**Addendum j to  
ASHRAE Guideline 36-2021**

**Proposed Addendum j to Guideline  
36-2021, High-Performance  
Sequences of Operation for HVAC  
Systems**

**First Public Review (November 2023)  
(Draft shows Proposed Changes to Current Guideline)**

The purpose of this addendum is to separate the ventilation logic for the Single Zone VAV Air Handling Units (SZVAV AHU) and VAV terminal units in the generic ventilation zones section. As currently written, variables such as  $V_{min}$ , unrelated to SZVAV AHU ventilation logic, remain in the generic ventilation sections whether or not they are used.

**Figure 5.2.1.3-1 Vmin\* and Vbz-P\* reset with CO2 loop.**

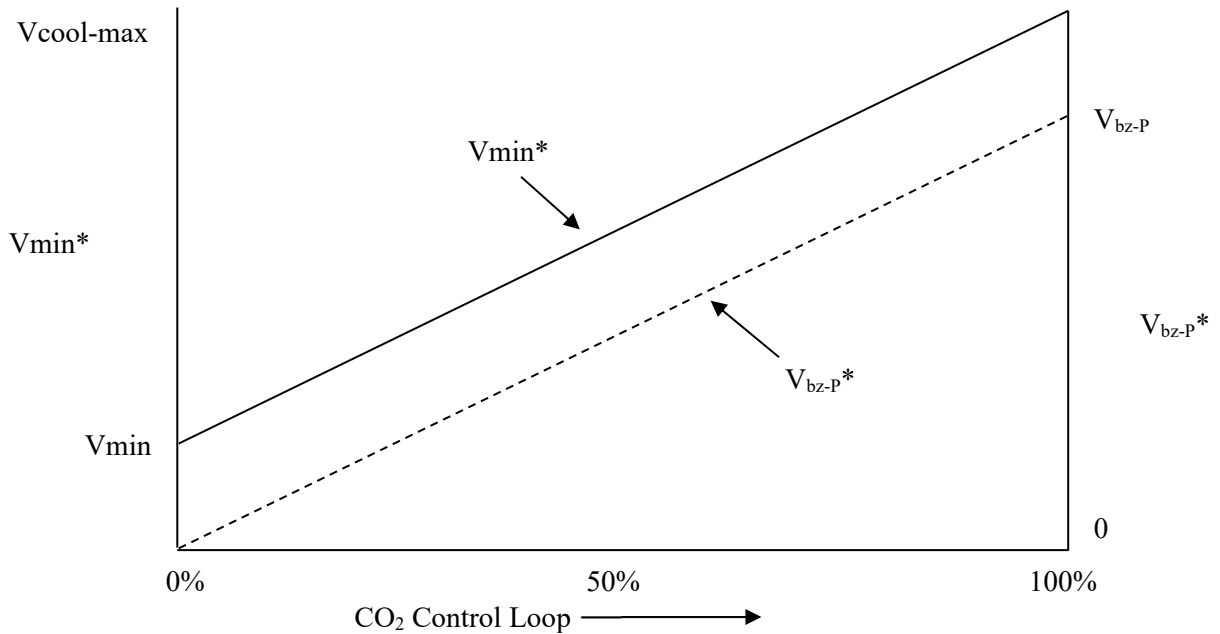
- (d) For cooling-only VAV terminal units, reheat VAV terminal units, constant-volume series fan-powered terminal units, dual-duct VAV terminal units with mixing control and inlet airflow sensors, dual-duct VAV terminal units with mixing control and a discharge airflow sensor, or dual-duct VAV terminal units with cold-duct minimum control:
  - (1) The CO<sub>2</sub> control loop output shall reset both the occupied minimum airflow setpoint ( $V_{min}^*$ ) and the population component of the required breathing zone outdoor airflow ( $V_{bz-P^*}$ ) in parallel.  $V_{min}^*$  shall be reset from the zone minimum airflow setpoint  $V_{min}$  at 0% loop output up to maximum cooling airflow setpoint  $V_{cool-max}$  at 100% loop output.  $V_{bz-P^*}$  shall be reset from 0 L/s (0 cfm) at 0% loop output up to the  $V_{bz-P}$  at 100% loop output. See Figure 5.2.1.3-1.

**Figure 5.2.1.3-2  $V_{min}^*$  and  $V_{bz-P}^*$  reset with CO<sub>2</sub> loop (parallel fan-powered).**

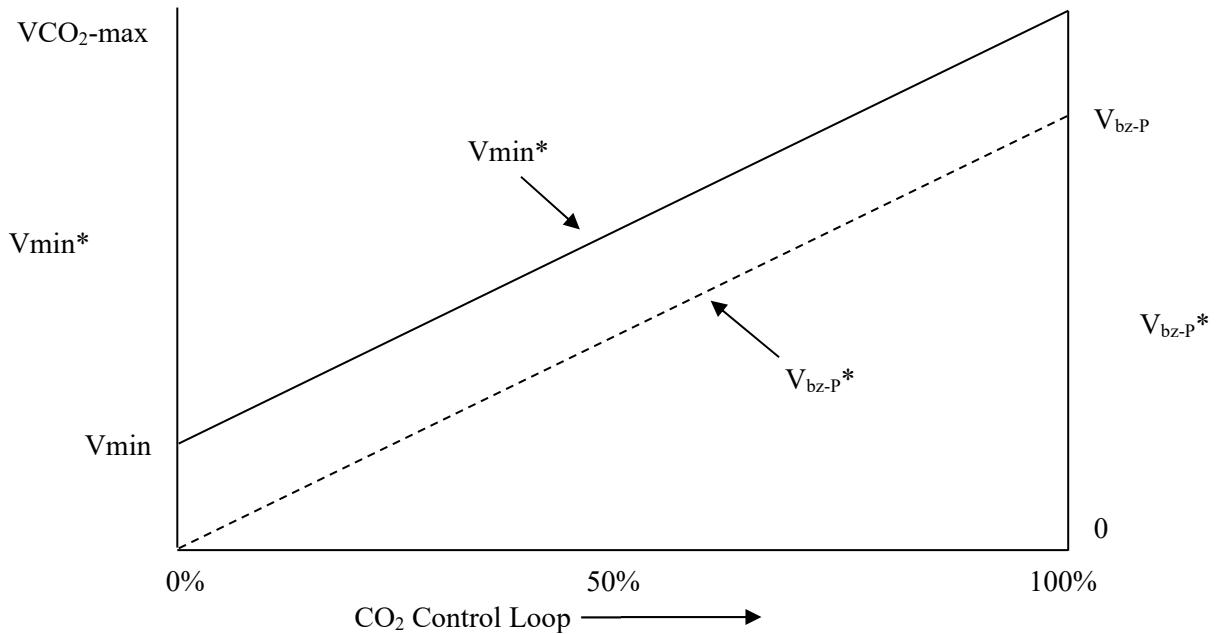
- (4) The CO<sub>2</sub> control loop output shall reset both the occupied minimum airflow setpoint Vmin\* and the population component of the required breathing zone outdoor airflow Vbz-P\* in parallel. Vmin\* shall be reset from the zone minimum airflow setpoint Vmin at 0% loop output up to maximum cooling airflow setpoint VCO<sub>2</sub>-max at 100% loop output. Vbz-P\* shall be reset from 0 L/s (0 cfm) at 0% loop output up to the Vbz-P at 100% loop output. See Figure 5.2.1.3-2.

Figure 5.2.1.3-3 V<sub>bz-P\*</sub> reset with CO<sub>2</sub> loop (SZVAV).

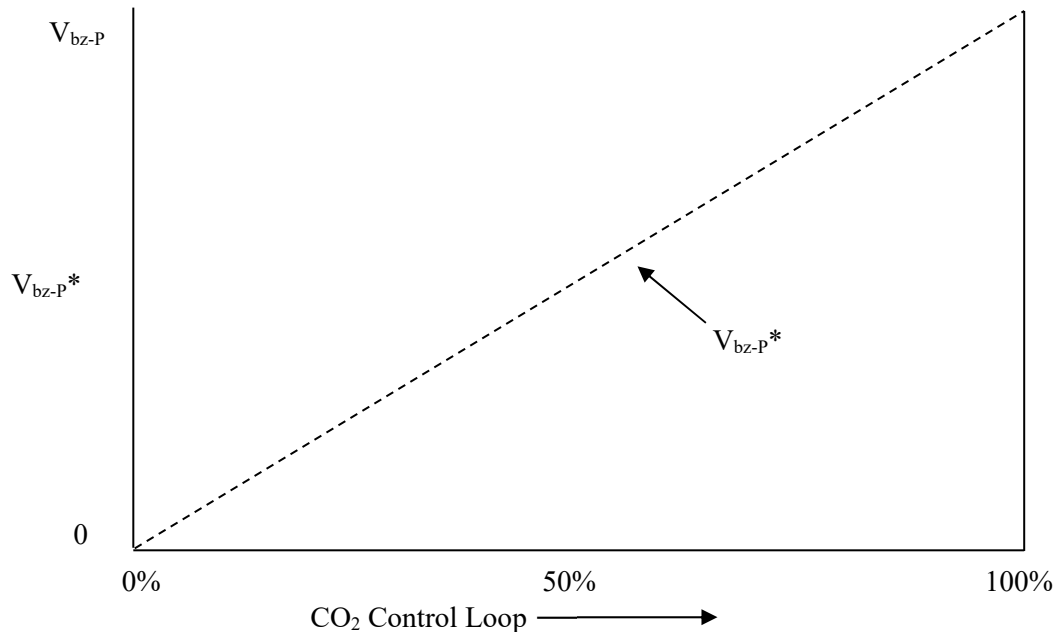
- (a) The minimum outdoor air setpoint MinOAsp is equal to V<sub>oz</sub>. The CO<sub>2</sub> control loop output shall reset the population component of the required breathing zone outdoor airflow V<sub>bz-P\*</sub> from 0 L/s (0 cfm) at 0% loop output up to V<sub>bz-P</sub> at 100% loop output. See Figure 5.2.1.3-3.

**Figure 5.2.1.4-1  $V_{min}^*$  reset with CO<sub>2</sub> loop.**

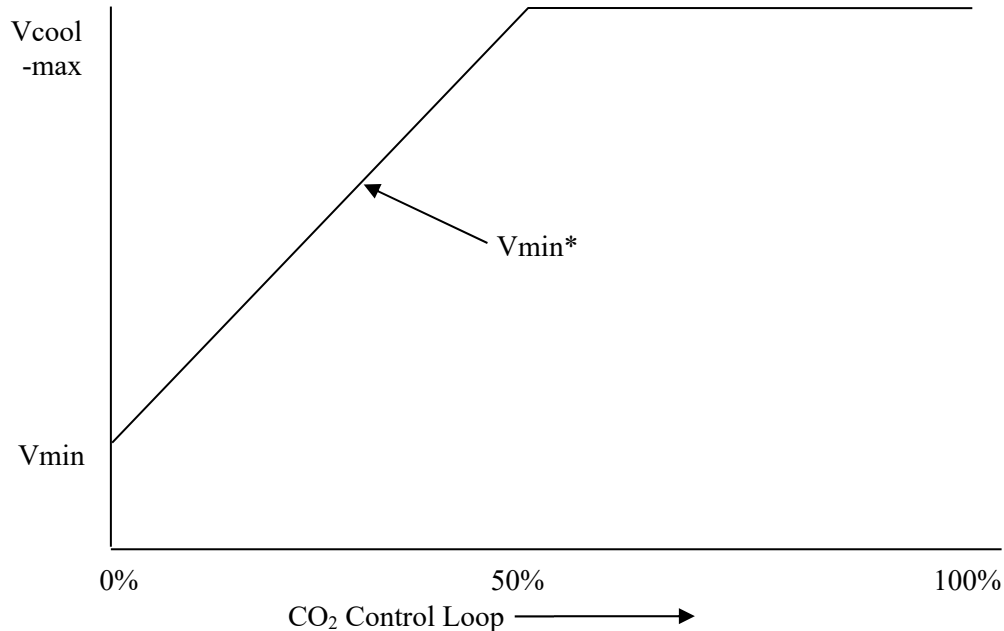
- (1) The CO<sub>2</sub> control loop output shall reset the occupied minimum airflow setpoint  $V_{min}^*$  from the zone minimum airflow setpoint  $V_{min}$  at 0% up to maximum cooling airflow setpoint  $V_{cool-max}$  at 50%, as shown in Figure 5.2.1.4-1. The loop output from 50% to 100% will be used at the system level to reset outdoor air minimum; see AHU controls.

**Figure 5.2.1.4-2 Vmin\* reset with CO<sub>2</sub> loop (parallel fan-powered).**

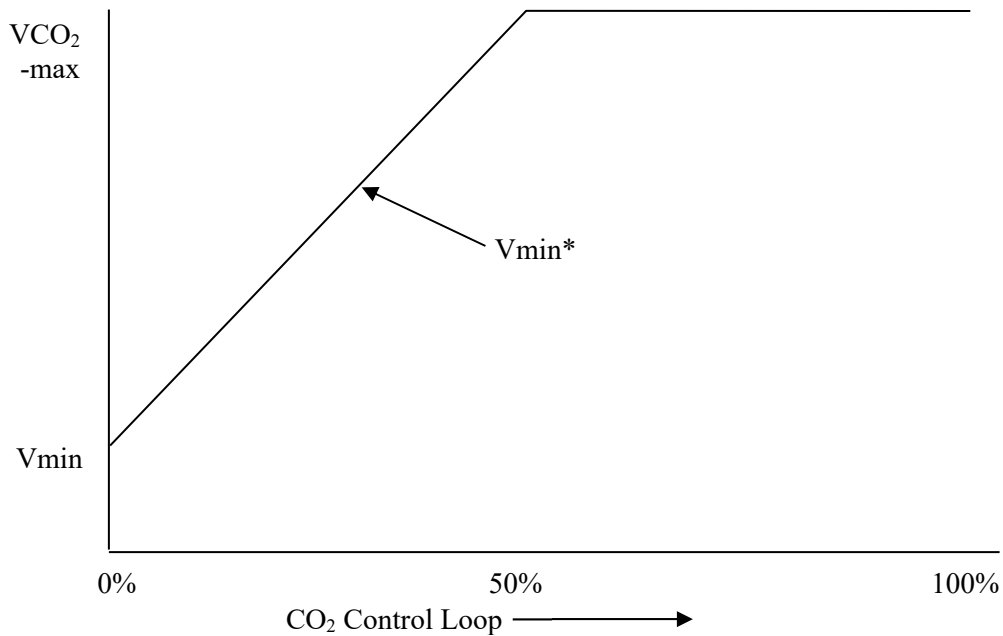
- (4) The CO<sub>2</sub> control loop output shall reset the occupied minimum airflow setpoint  $V_{min}^*$  from the zone minimum airflow setpoint  $V_{min}$  at 0% up to maximum cooling airflow setpoint  $V_{CO2-max}$  at 50%, as shown in Figure 5.2.1.4-2. The loop output from 50% to 100% will be used at the system level to reset outdoor air minimum; see AHU controls.

Figure 5.2.1.4-3  ~~$v_{min} = \text{MinOAsp}$~~  reset with CO2 loop (SZVAV).

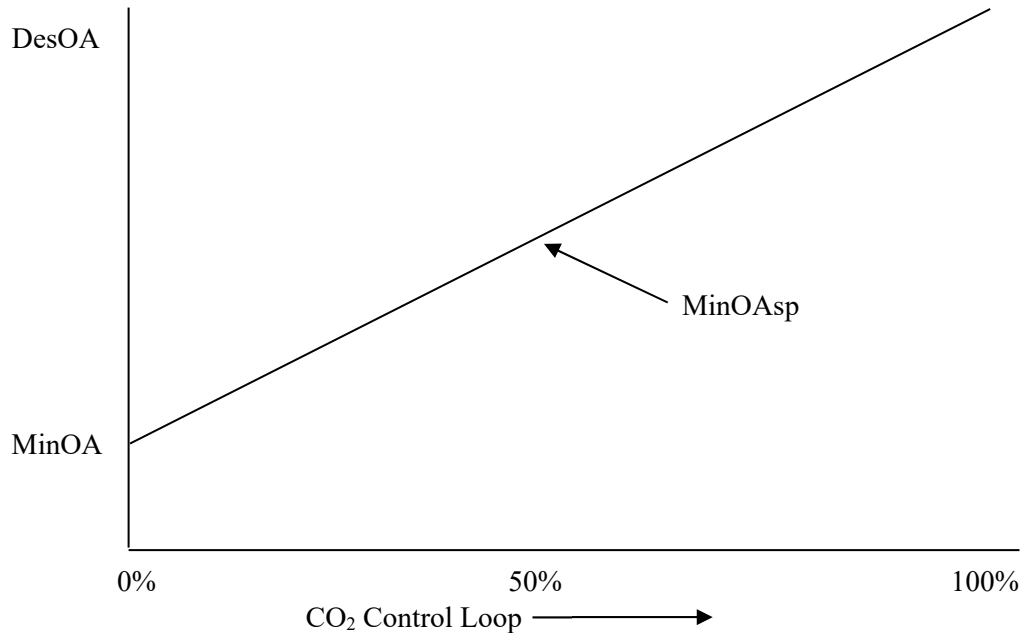
- (d) If the zone has a CO<sub>2</sub> sensor:
  - (1) See Section 3.1.1.3 for CO<sub>2</sub> setpoints.
  - (2) During Occupied Mode, a P-only loop shall maintain CO<sub>2</sub> concentration at setpoint; reset from 0% at setpoint minus 200 PPM and to 100% at setpoint.
  - (3) Loop is disabled and output set to zero when the zone is not in Occupied Mode.
  - (4) The minimum outdoor air setpoint MinOAsp shall be reset based on the zone CO<sub>2</sub> control-loop signal from MinOA at 0% signal to DesOA at 100% signal. See Figure 5.2.1.4-3.
- (e) DesOA otherwise.
